CITY PLANNING COMMISSION

- APPLICATION:
1. Negative Declaration
 2. Rezone from Garden Apartment, R-2A, to Townhouse, R-1A
 3. Special Permit to develop halfplex units
 4. Subdivision Modification to waive sewer and water services
 5. Tentative Map (P-82-055)

LOCATION: Southwest corner of American Avenue and Harding Avenue

APPLIC. NO. P-82-055 MEETING DATE April 8, 1982 CPC ITEM NO. 18

TENTATIVE SUBDIVISION MAP

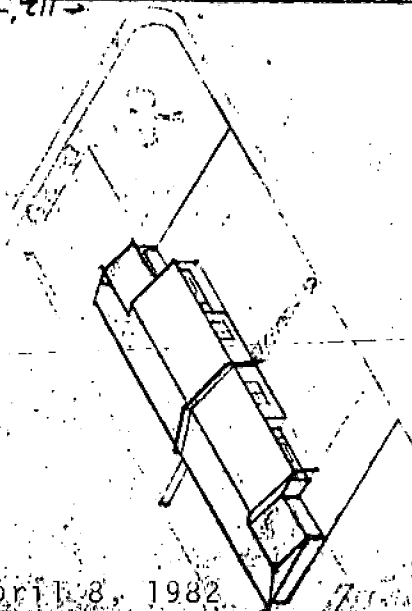
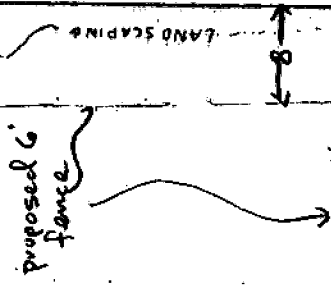
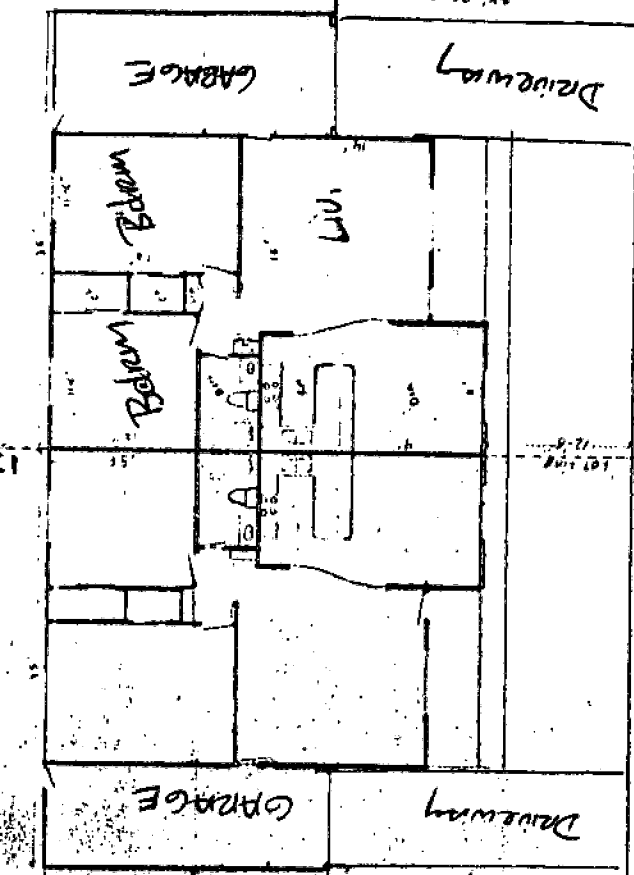
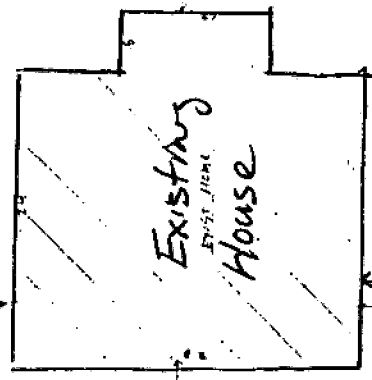
- a. Place the following note on the final map: Water and sewer service connections do not exist between the main lines and parcels B and C. These services must be paid for and installed at the time of obtaining building permits;

- b. File the necessary segregation requests and fees to segregate existing assessments;
- c. Pursuant to City Code Section 40.1302 (Parkland Dedication), the applicant shall submit to the City an appraisal of the property to be subdivided and pay the required parkland dedication in-lieu fees. The appraisal shall be dated not more than 90 days prior to the filing of the final map;

- d. Pursuant to City Code Section 40.319-1, the applicant shall indicate easements on the final map to allow for the placement of centralized mail delivery units. The specific locations for such easements shall be subject to review and approval of the City Engineer after consultation with the U.S. Postal Service;

- e. Indicate location of sewer and water services to the existing residence. Separate services are required to this residence. Easements for such services shall be provided for or dedicated as required by City Engineering;

- f. Applicant shall dedicate a five-foot PUE along the southern property line.

Proposed - Duplex for American Avz.
Dwn. by Sarrac Beck
Scale: 3/8" = 1'-0"
Date: Dec 81

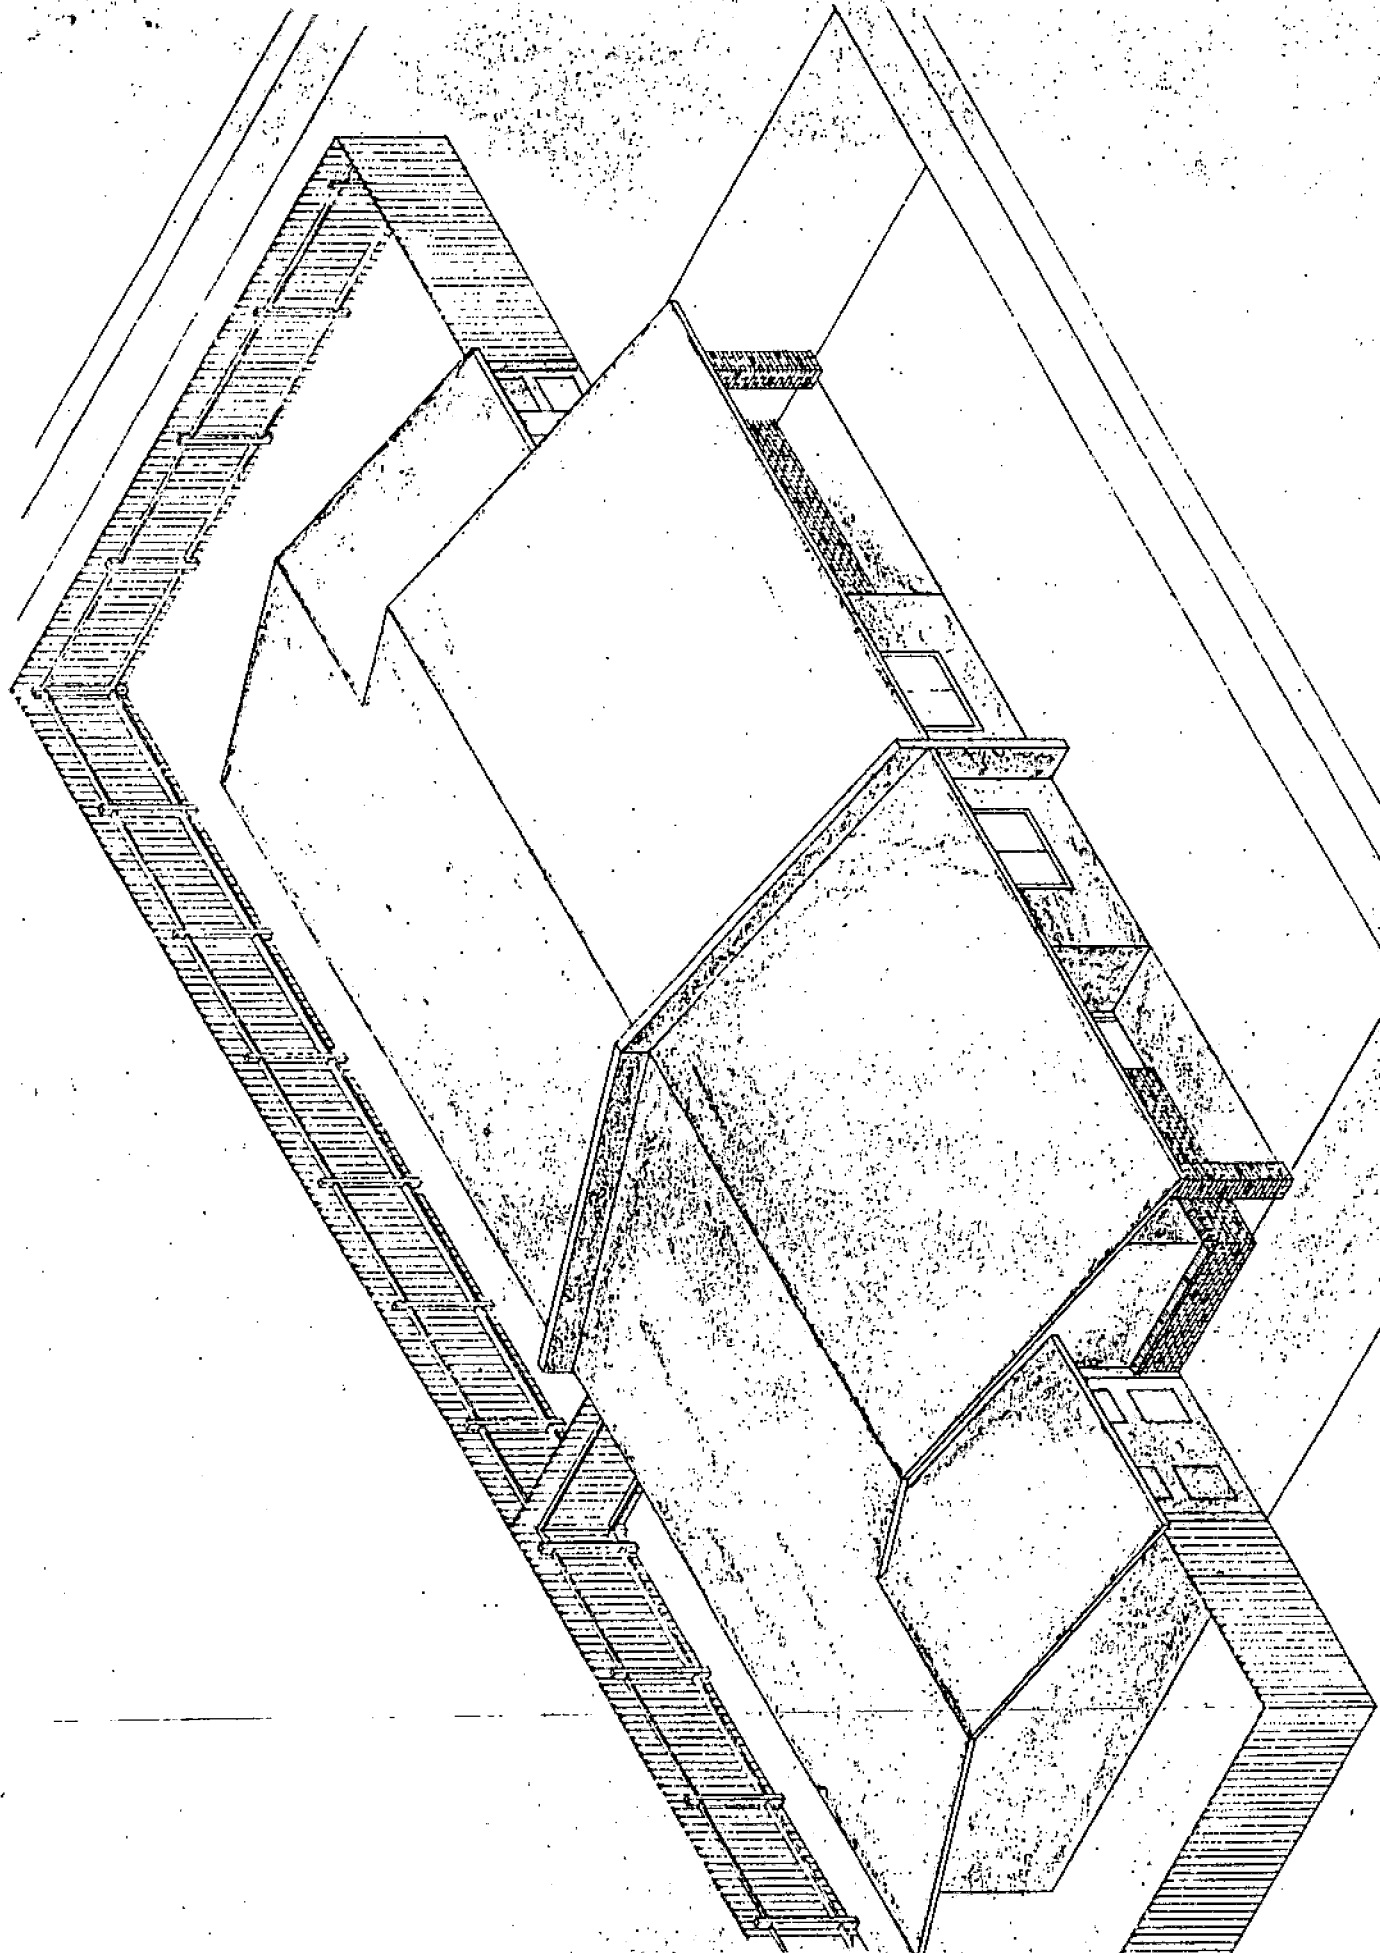
3. Staff has concerns with the design of the structure and its compatibility with the surrounding residential neighborhood. Specifically, the proposed firewall parapet between the units appears out of place for a residential structure. In addition, in order to provide additional design relief, roofing material should be utilized that will provide a variation in depth similar to wood shingles or shakes.
